**Norwich to Tilbury – Deadline 5 submission  
Burstall Parish Council (10/6/26)**

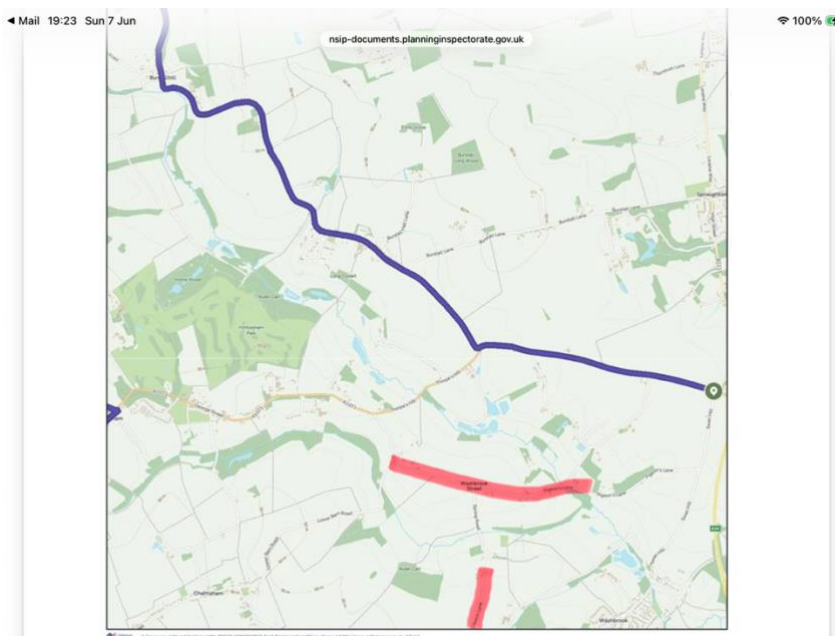
These statements take no account of any cumulative impact, the impact on the ‘historic character’ of the area, or the impact on the wider rural context (as defined by Virginia Brewer), and must therefore be revisited as we believe they are understating the true impact. These statements are simply incorrect and require review.

##### **b. Burstall Lane, Burstall & Flowton Road, Flowton.**

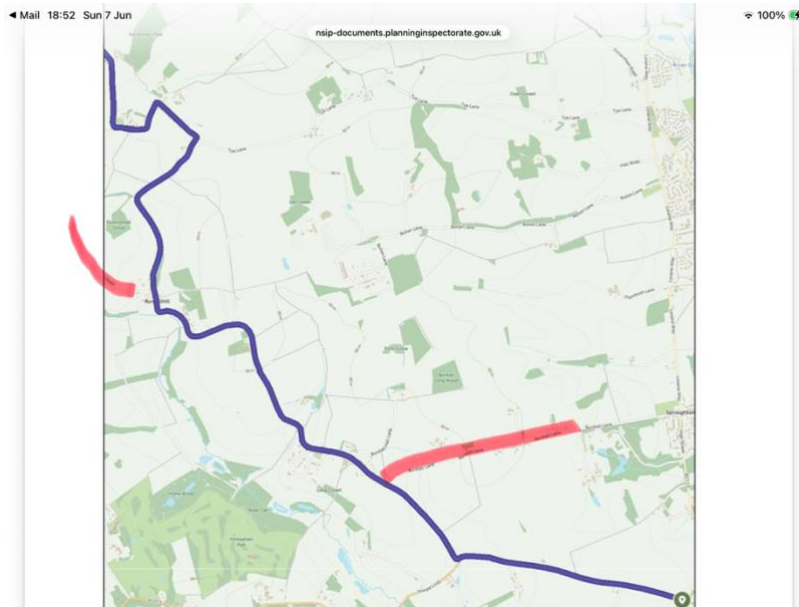
Significant gaps - Burstall Lane is self explanatory as the pylon cross this lane which also crosses the ridge line which the pylons will use to march southwards. Viewing here will highlight how a small move of the pylon route east would move them onto lower ground and therefore lessen all views. Flowton Road is high ground to the north west of the substation giving good views of the north and west of the substation. The route that was taken here (the channel) is low ground with no visibility of the substation and was therefore pointless in terms of showing local impact.

**c. Walking route -views of the substation from the south and view of the ground east of Round Wood and Burstall Long Wood.**

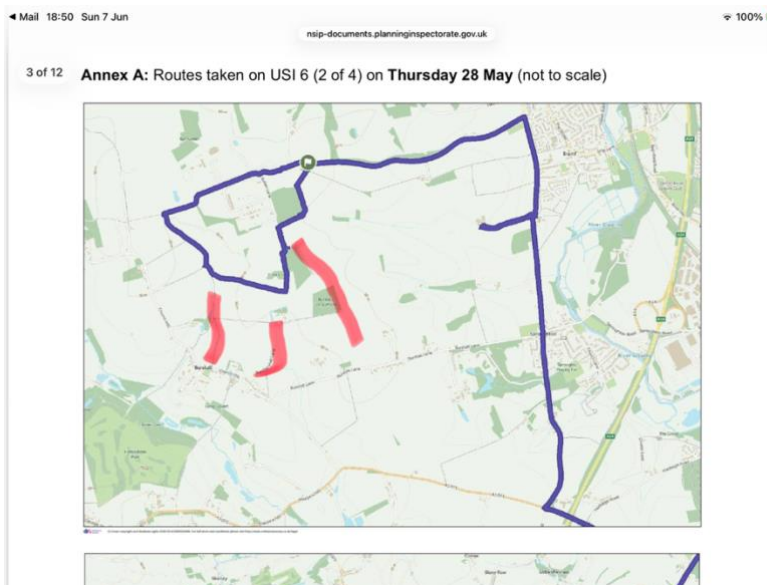
An opportunity missed to see the full impact from Burstall village. With only a small detour south, the impact specifically from the village would be visible, which is not nearly as obvious from the route which was taken. On the route walked, the inspectors will not have clearly seen how the ground falls to the east of Round Wood and Burstall

Long Wood, and therefore how a small move of the pylon route east here would have a significant impact of visibility of the pylons. However, the inspectors will have seen the advantages of routing the pylon exit from the substation east of Bullen Wood.

**d. Gaps superimposed onto N2T interactive map.**

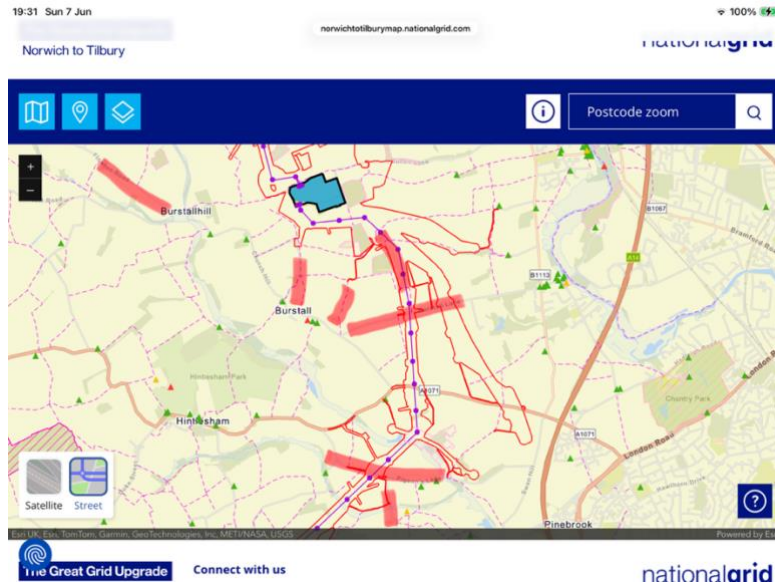
The gaps in terms of the pylon route can be seen clearly below.

**e. Contour map showing viewing gaps (high ground) in red. Noting route taken in low ground (blue contours).**

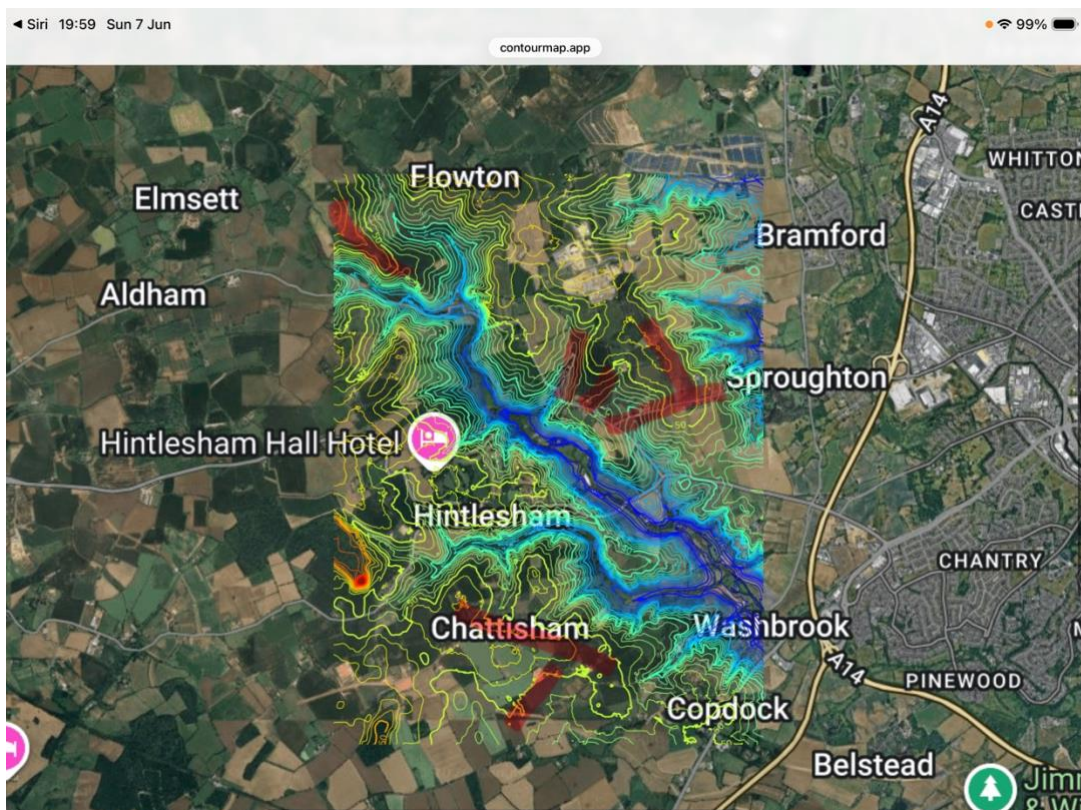
Burstall Parish Council wish to highlight gaps in the routes chosen to view the impact of the pylon route in the vicinity of Burstall village and the Bramford Substation. These are significant viewing areas which show the impact at their greatest and are shown in red in the attached maps. We have also drawn the gaps onto a copy of the interactive map to show how the gaps relate to the pylon route and attached a contour map to show viewing gaps. Our offer to accompany the Inspectors on a site inspection covering these gaps remains.
